Ref: P2207053

**RE: Vantage Data Centres Dub 11 Ltd., Construction of 1No. Two Storey Data Centre,
Townlands of Ballybane & Kilbride within Profile Park, Clondalkin, Dublin 22
Planning Reg. Ref. No. SD22A/0420**

**DUB13 – ACCESS BRIDGE
CONSTRUCTION METHOD STATEMENT**

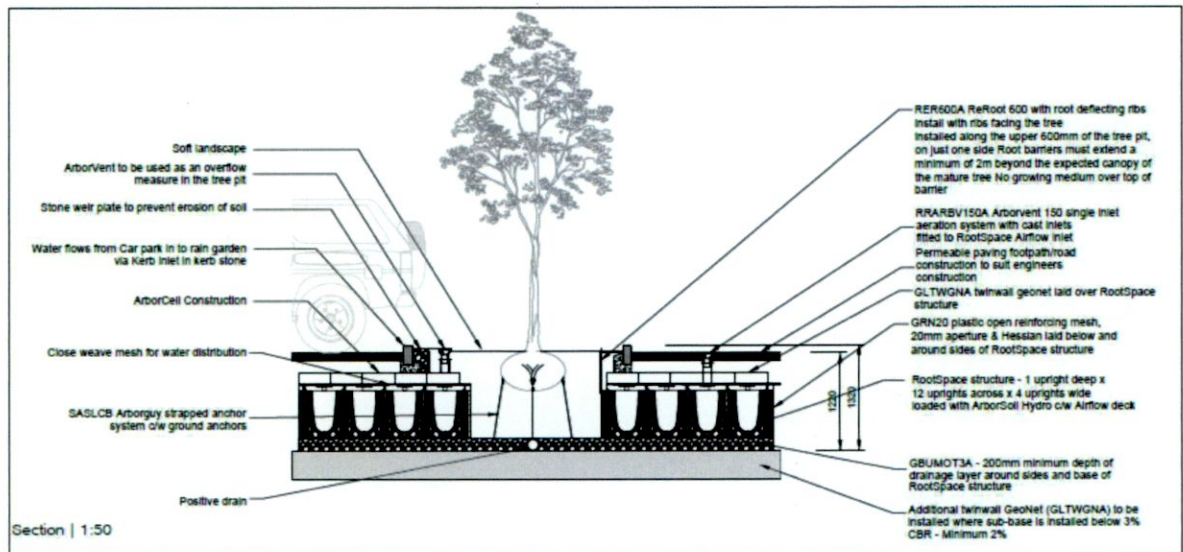
(C) SUDs Management - The applicant is requested to submit a comprehensive SUDS Management Plan to demonstrate that the proposed SUDS features have reduced the rate of runoff into the existing surface water drainage network. A maintenance plan should also be included as a demonstration of how the system will function following implementation.

The hydrobrake mechanisms are provided within manholes in order to restrict the outflow to the rates specified. Most manufacturers of these products provide cleaning, maintenance and repair service teams and partners, providing specialist operations and maintenance (O&M) cover, keeping water management equipment and systems operating at peak performance, effectiveness and efficiency.

The maintenance of the detention basins and flood compensatory storage area will be in line with recommendations from the Landscape Architect (KFLA) on the scheme and / or recommendations by Parks Department.

TYPICAL BIO SWALE DETAIL

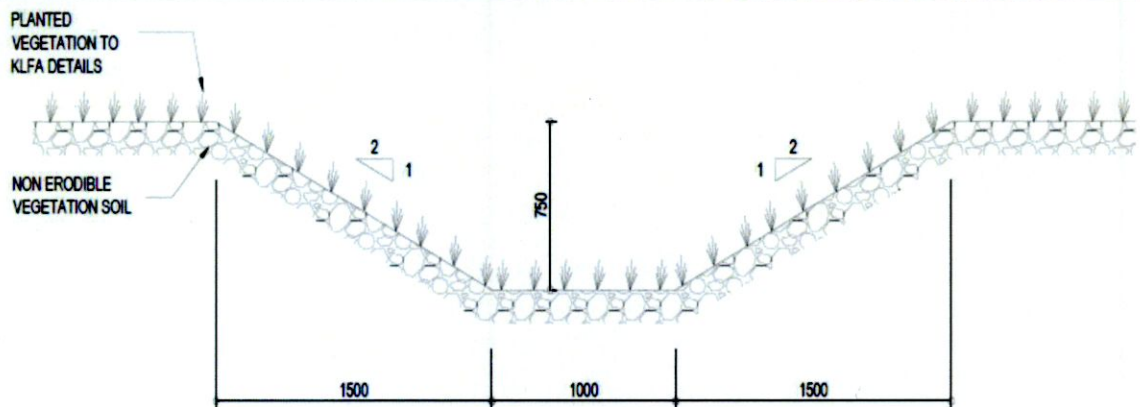
Item 14: (a) where possible, the applicant is requested to replace proposed overflow pipe with an open swale or natural open channel.

The previously piped outfall from Detention Basin 1 into the stream, has been replaced by a natural open channel / open swale – refer Dwg. No. DUB13-DR-UG-C127-V2-WS4 Rev. V3.

Typical Bio Swale detail below.

Vdes = 0.7 m/s
Qdes = 0.94 m³/s

View Looking West from the Existing Falcon Avenue Culvert

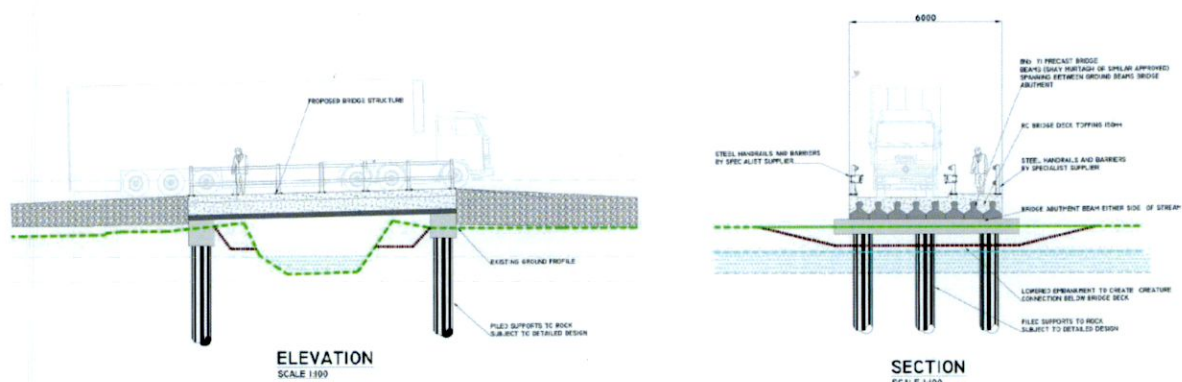
14. (c) Significant concerns are maintained in relation to the proposed culverting of the stream and it is considered that alternative design solutions should be explored to avoid the proposed culverting.

Consideration of alternative design in place of the culvert result in the requirement for the construction of a bridge across the stream linking the two sites the position of the bridge abutments/support structure was discussed in relationship to the height of the stream banks and the levels of the proposed development on either side into which the bridge line was proposed.

Consideration has also been given to the overall width of the bridge structure to minimum, with the crossing being reduced to single carriageway width with signal controls on each side. A footpath is proposed on one side of the bridge.

Provision has been made for a creature underpass by lowering the stream embankment on below the bridge deck on either side of the stream to create a safe nature corridor.
